COUNCIL ASSESSMENT REPORT
HUNTER AND CENTRAL COAST REGIONAL PLANNING PANEL

PANEL REFERENCE & DA NUMBER	PPSHCC-350 DA/2113/2024 (PAN-498653 & CON-25158)
PROPOSAL	Demolition of dwelling, tree removal and construction of a 113 place child care centre and associated works.
ADDRESS	167 Serpentine Road, Terrigal Lot 2 DP 746654
APPLICANT	The Trustee for Malachite Superannuation Fund
OWNER	The Trustee for Malachite Superannuation Fund
DA LODGEMENT DATE	16 January 2025
APPLICATION TYPE	Local Development
REGIONALLY SIGNIFICANT CRITERIA	Section 2.19 (1) and Clause 5 of <i>State Environmental Planning Policy (Planning Systems) 2021</i> declares the proposal regionally significant development as the development comprises private infrastructure and community facilities with a capital investment value of more than \$5 million.
CIV	\$7,580,000.00 (excluding GST)
CLAUSE 4.6 REQUESTS	N/A
KEY SEPP/LEP	<i>State Environmental Planning Policy (Planning Systems) 2021</i> <i>State Environment Planning Policy (Transport and Infrastructure) 2021</i> <i>State Environmental Planning Policy (Biodiversity and Conservation) 2021</i> <i>State Environmental Planning Policy (Resilience and Hazards) 2021</i> <i>St

Figure 11 Recommended Acoustic Barrier

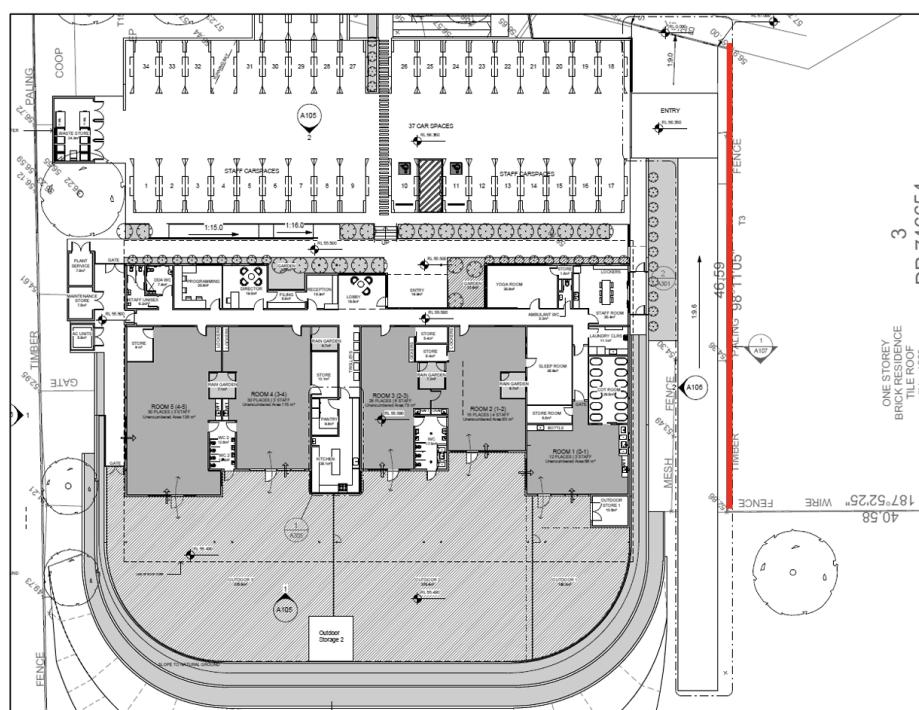
Acoustic fences either at the boundary or the retaining wall line (indicated by the red line) of min. 1.8 m height must be installed at the boundary.

The acoustic fences must have a minimum acoustic performance of $Rw25$. Structural requirements must be checked with the relevant authority. The acoustic barrier must be of solid construction (with no air gaps or penetrations including the connections and structural bases) such as:
